Calvert Cliffs Nuclear Power Plant, Units 1 and 2
Renewed Facility Operating License Nos. DPR-53 and DPR-69
NRC Docket Nos. 50-317 and 50-318

Subject: License Amendment Request Regarding Emergency Operations Facility (EOF) and Joint Information Center (JIC) Relocation and Consolidation

Calvert Cliffs Nuclear Power Plant Emergency Plan Mark-up

Figure 5-2, Emergency Operations / Joint Information Center Facility

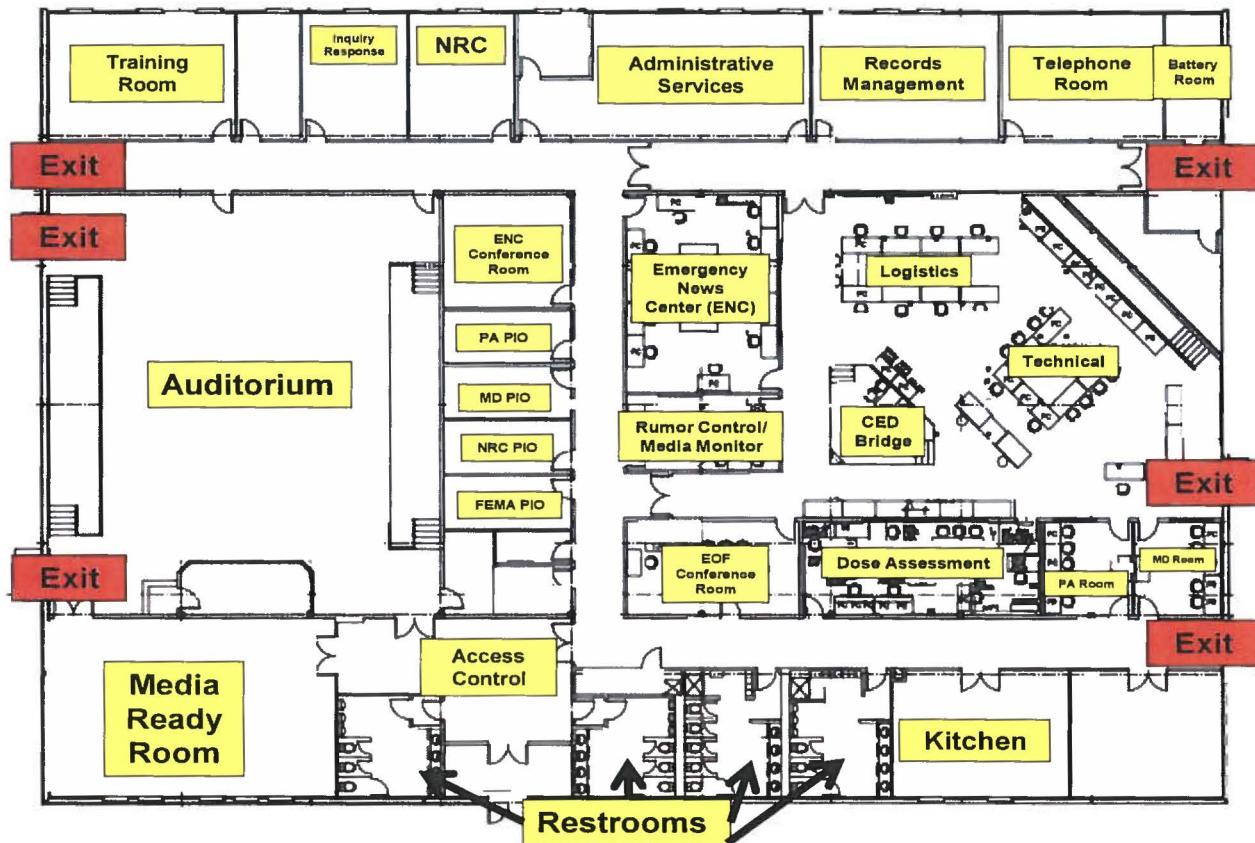
1. The Emergency Operations Facility floor plan is shown in Figure 5-2, Emergency Operations Facility, and its location at 175 North Cain Road, in Coatesville, Pennsylvania ~~Calvert County~~ is shown in Figure 5-3, Emergency Operations Facility and Joint Information Center Location.
2. The EOF is the location where the Corporate Emergency Director will direct a staff in evaluating and coordinating the overall company activities involved with an emergency.

- 3.2. The Joint Information Center is located about 115 ~~twelve~~ miles from the site, in ~~Calvert Industrial Park~~ ~~Coatesville, Pennsylvania~~ ~~Skipjack Road at Hallowing Point Road~~. It is a well- engineered structure for design life of the ~~Calvert Cliffs~~ nuclear power plants it supports.

Figure 5-2, Emergency Operations / Joint Information Center Facility

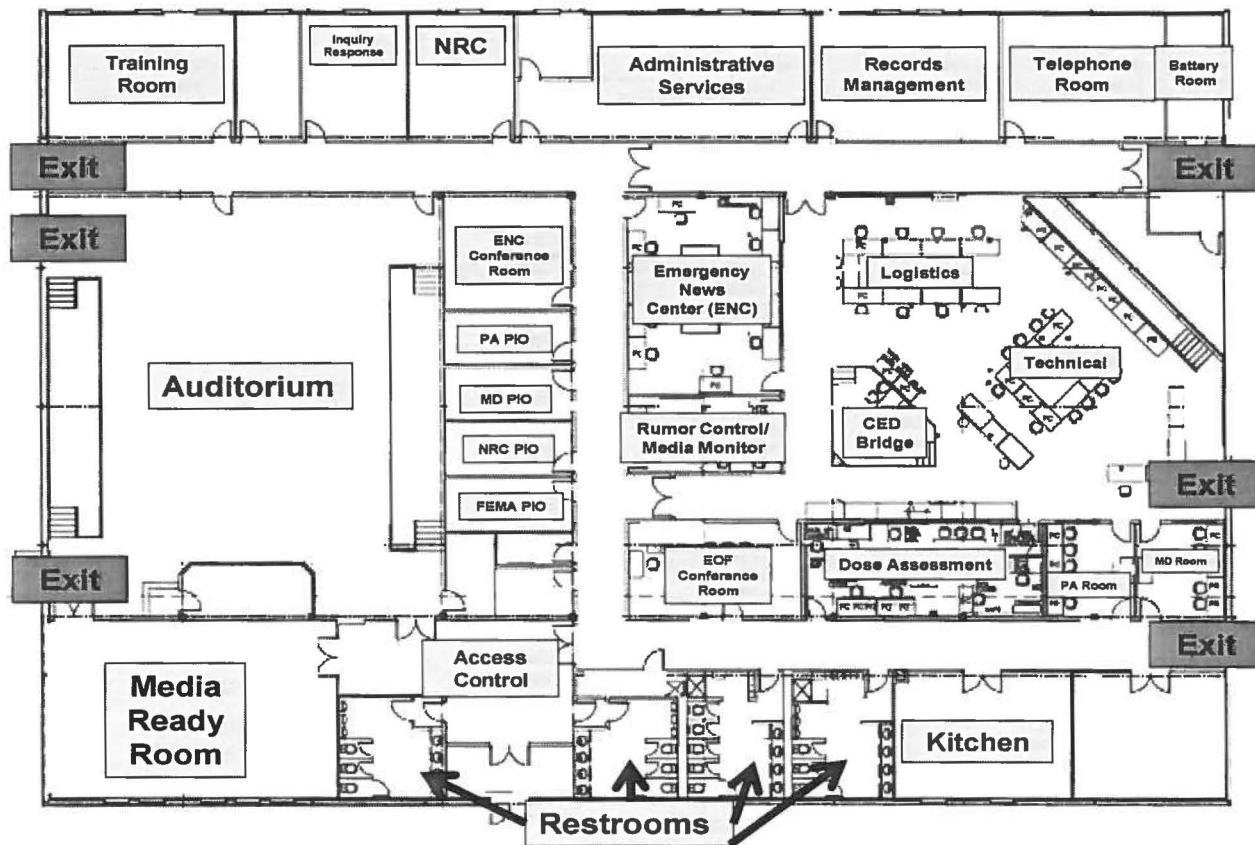
1. The Emergency Operations Facility floor plan is shown in Figure 5-2, Emergency Operations Facility, and its location at 175 North Caln Road, Coatesville, Pennsylvania is shown in Figure 5-3, Emergency Operations Facility and Joint Information Center Location.
2. The EOF is the location where the Corporate Emergency Director will direct a staff in evaluating and coordinating the overall company activities involved with an emergency.
